## Firmware 2.06.3 bug list:

## List of bugs/improvement requests

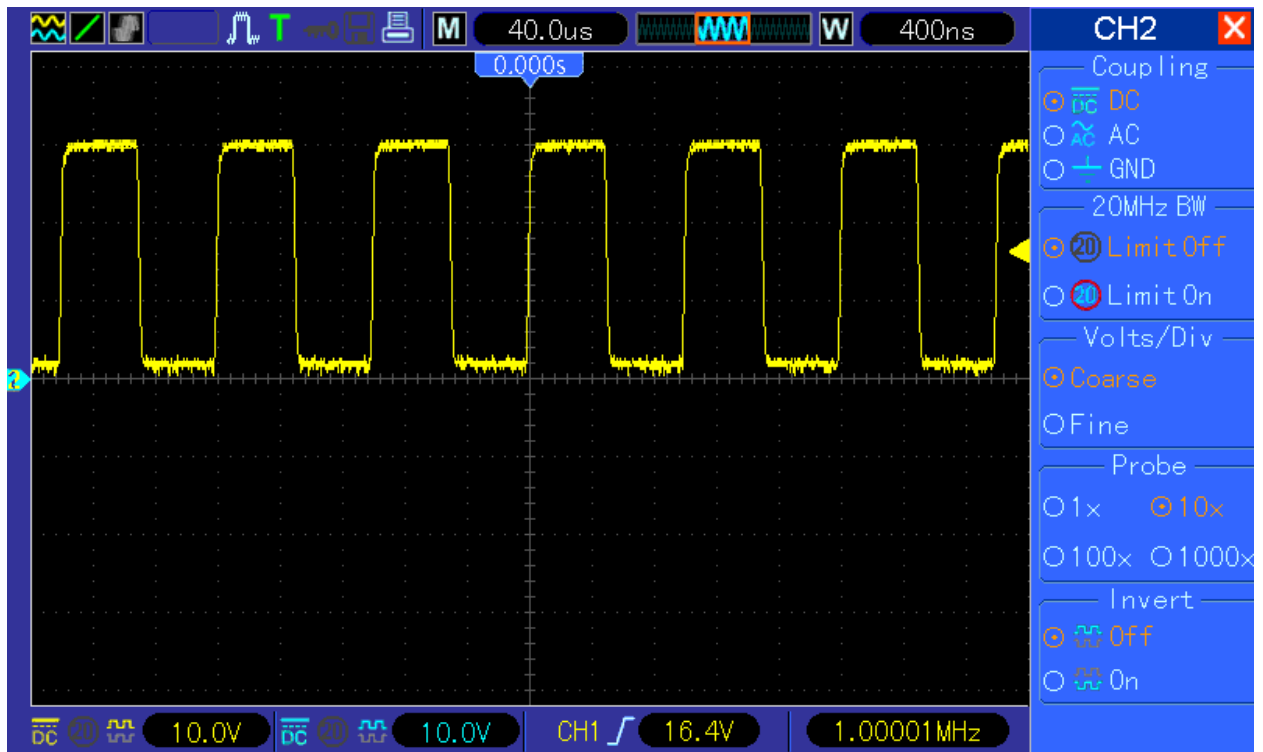
36. If possible change the Frequency Counter to display in mHz resolution when counter value between 1Hz and 99.999kHz (99999Hz). If not possible change displayed value to cut (trailing) zeros, when there is no mHz no need to see zeros instead (e.g 10Hz should be shows as 10Hz and not 10.0000Hz). This might be sometimes very confusing for the user, imagine e.g. frequency of 32.768Hz – the counter will show 32.000Hz (and Wave measure 32.76Hz).

36. Not a bug, but who need to see trailing zeros?
37. Turn Timebase knob one position forth and back.
38. This is funny bug, isn't?
39. Turn Timebase knob one position forth and back, in most cases the Sampling Rate within FFT will be then updated to proper value.
40. ~~Ensure that no more than 10 file on the Flash Drive.~~
41. ~~No fix for this~~

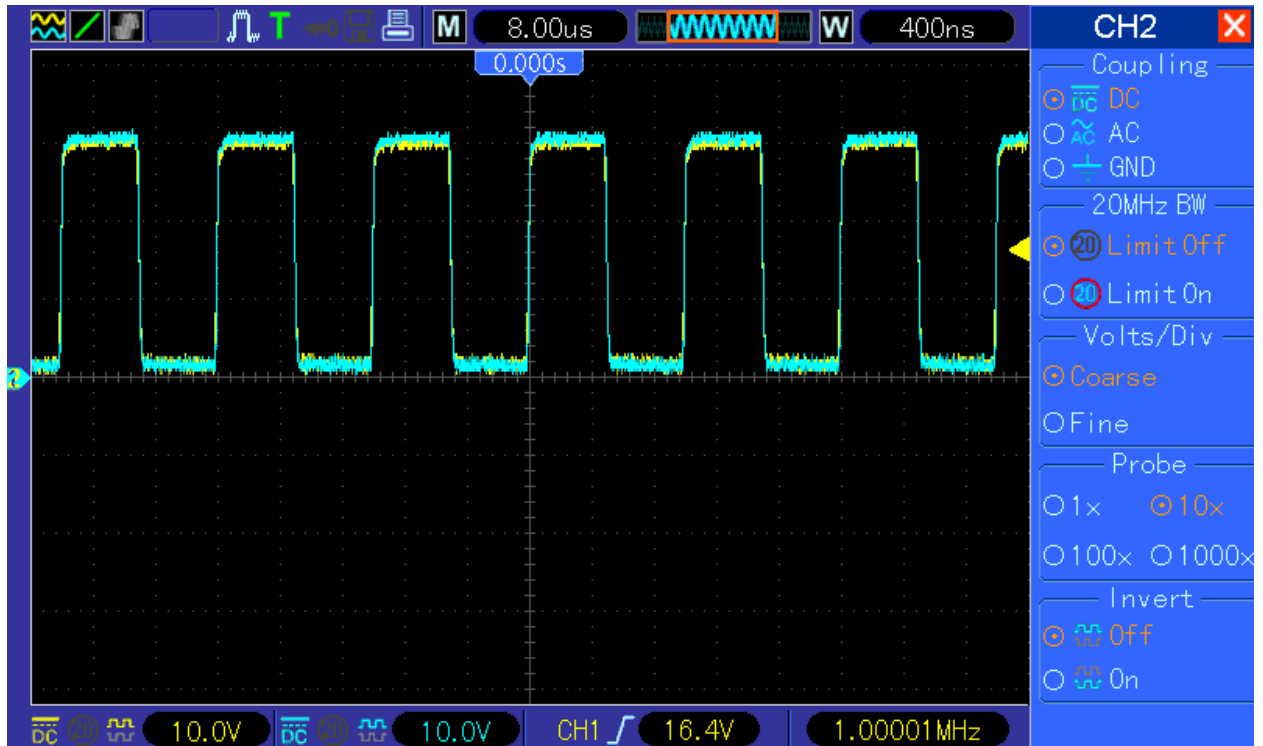
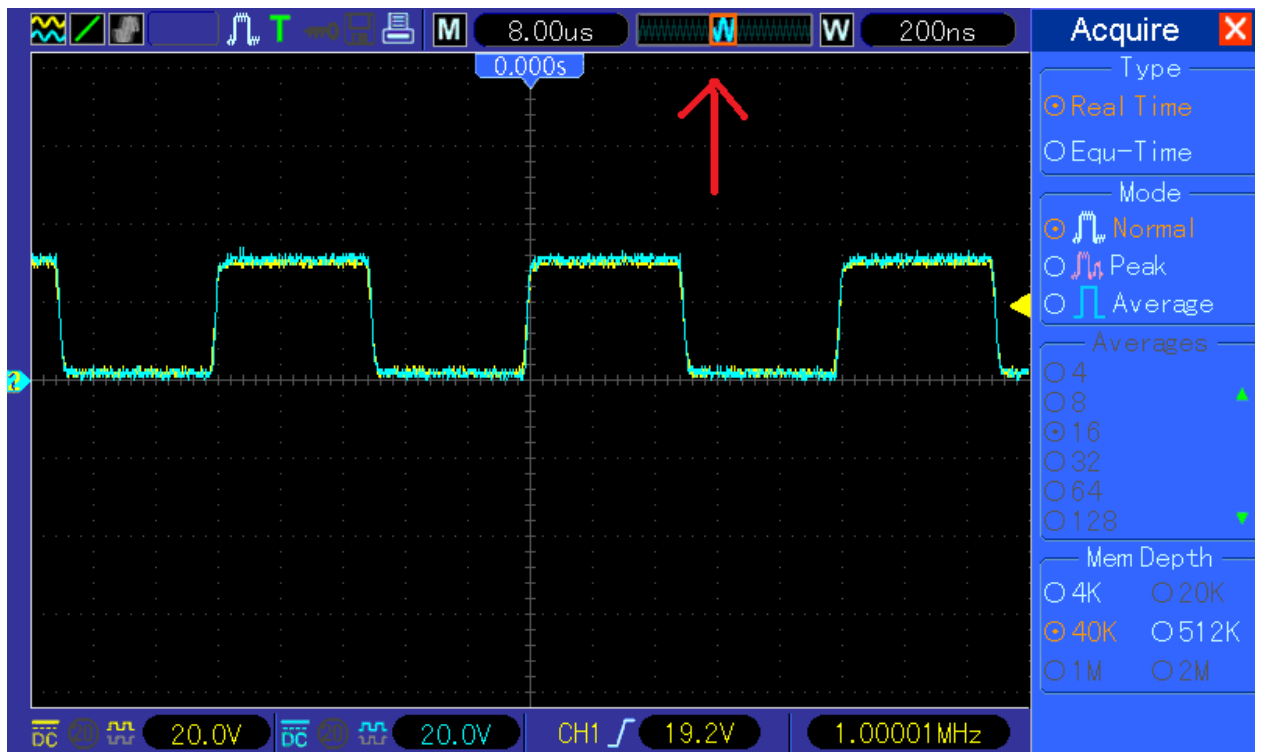
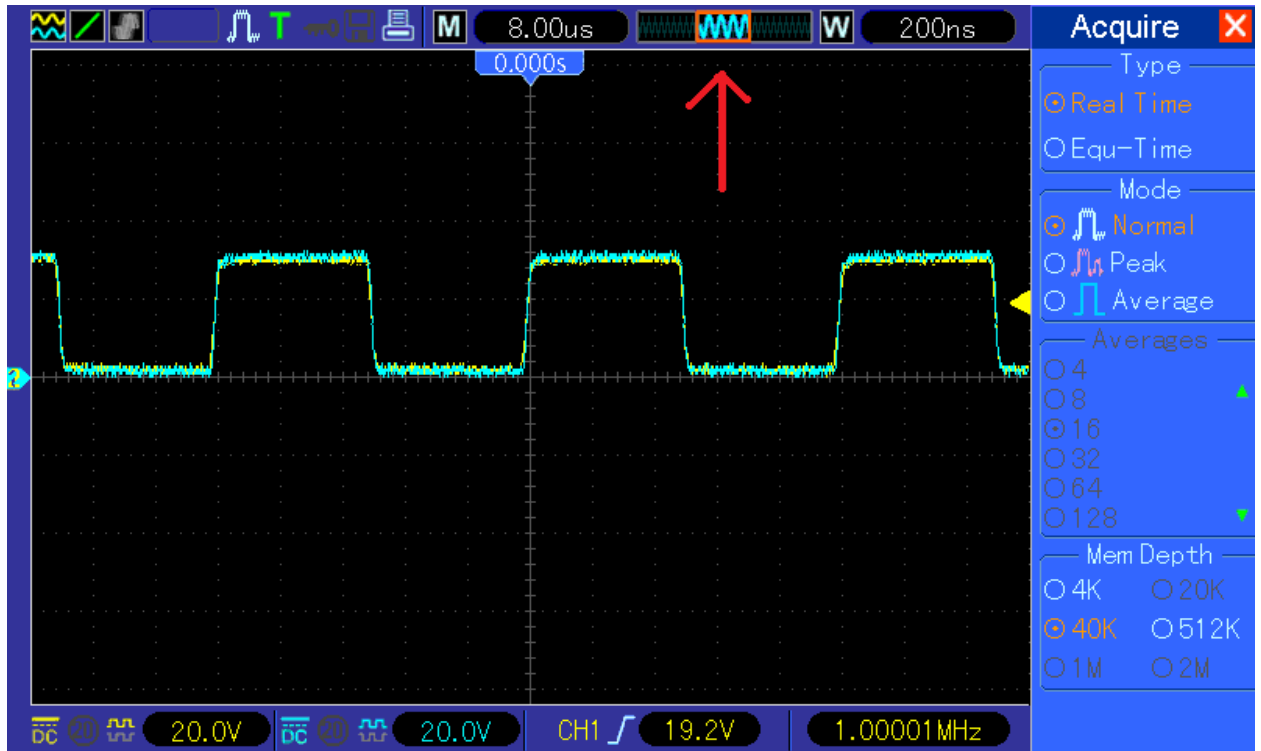
37. With Long Memory enabled (40k, 512k, 1M, 2M?) when the WTB is 400ns/DIV (and lower, up to 2ns/DIV) when enabling second channel the indicator in status line will be already displayed but the waveform is missing. Additionally the CH2 LED is off :

But after changing Timebase (or wave position) one position forth and back the second channel waveform will get displayed and LED gets on :

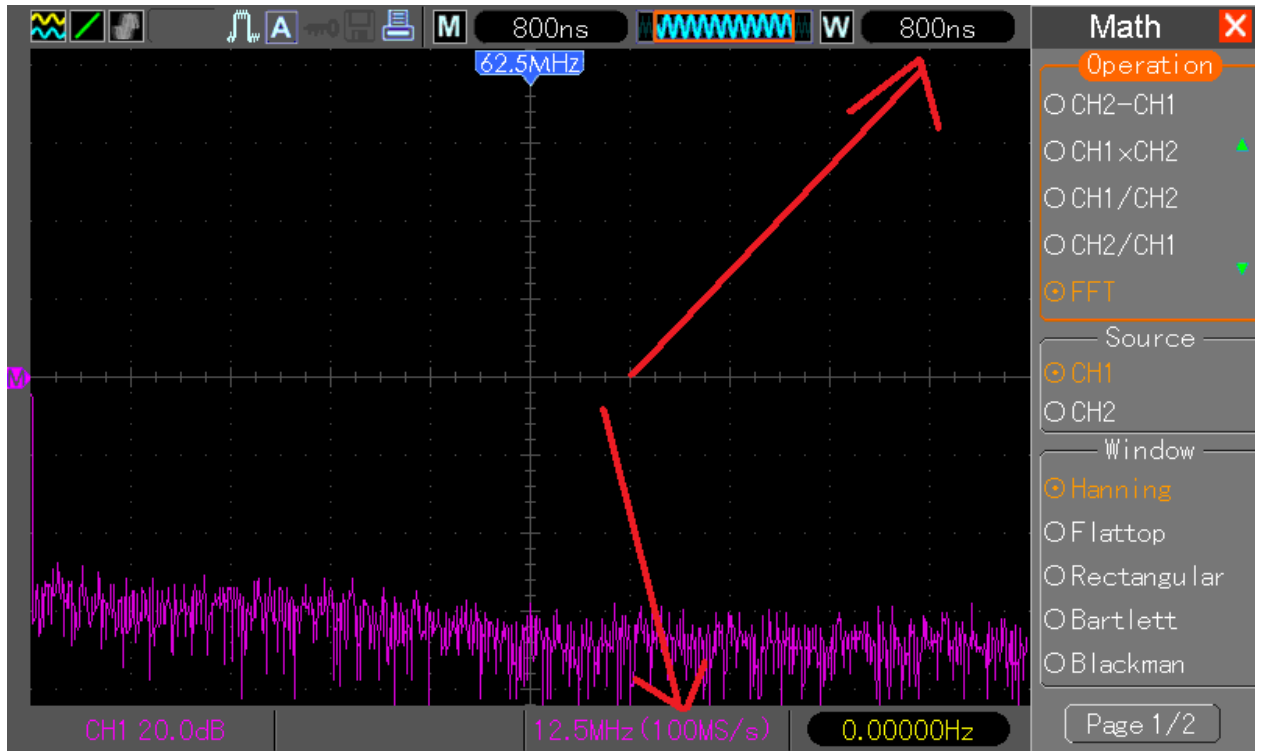
38. MTB Area indicator is blinking! Select 40k depth (or 512k), enable both channels set WTB to 400ns/DIV or 200ns/DIV and watch the area blinking :

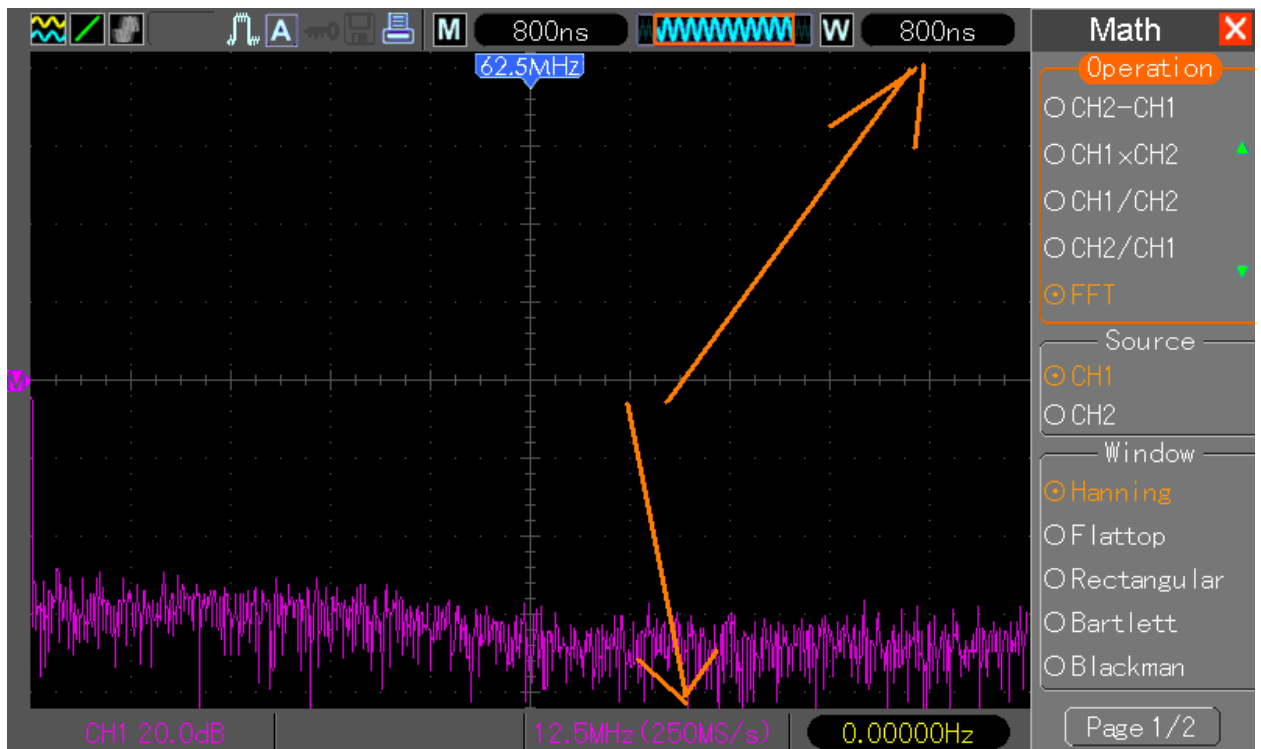
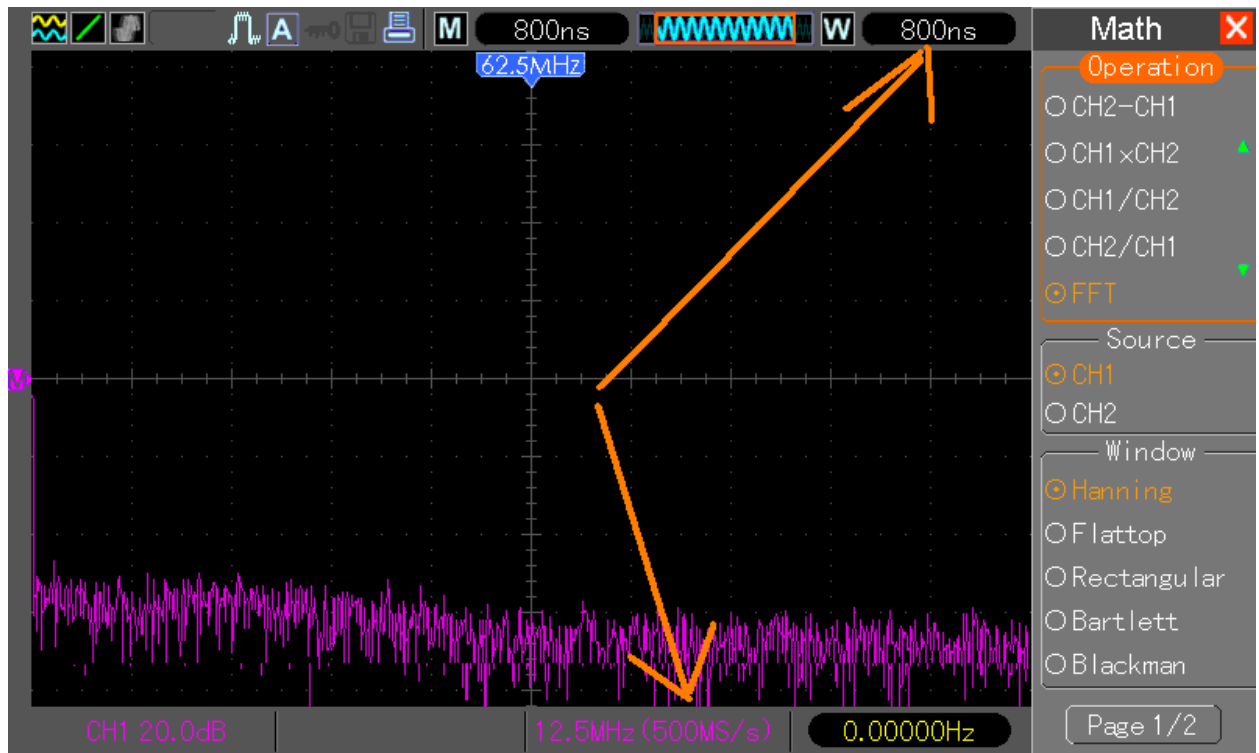
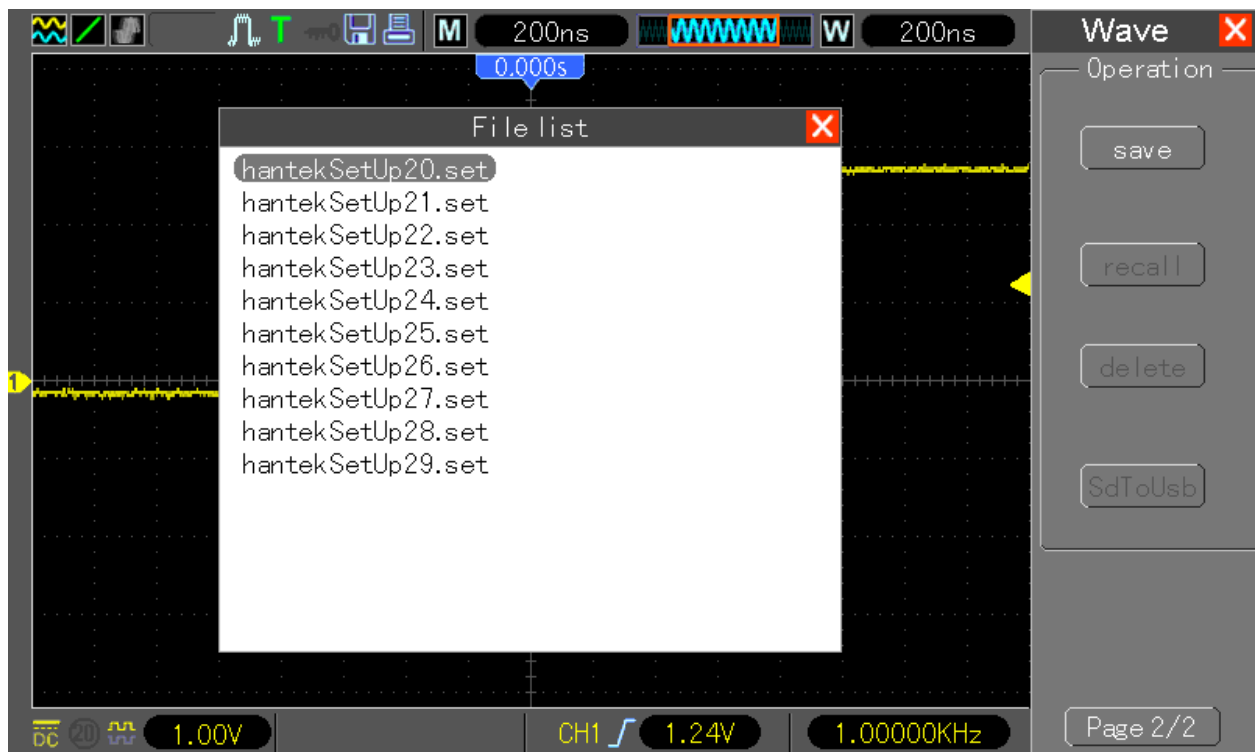
39. Within FFT the information in status bar is not always showing the proper sampling rate, sometimes even jumping from proper to bad value. As the FFT cursor is taking in count the sampling rate, the measure value might be not correct. Example random values in 800ns/DIV FFT , here 100MS/s

then 250MS/s (but still 800ns/DIV)

and here 500MS/s (but still 800ns/DIV)
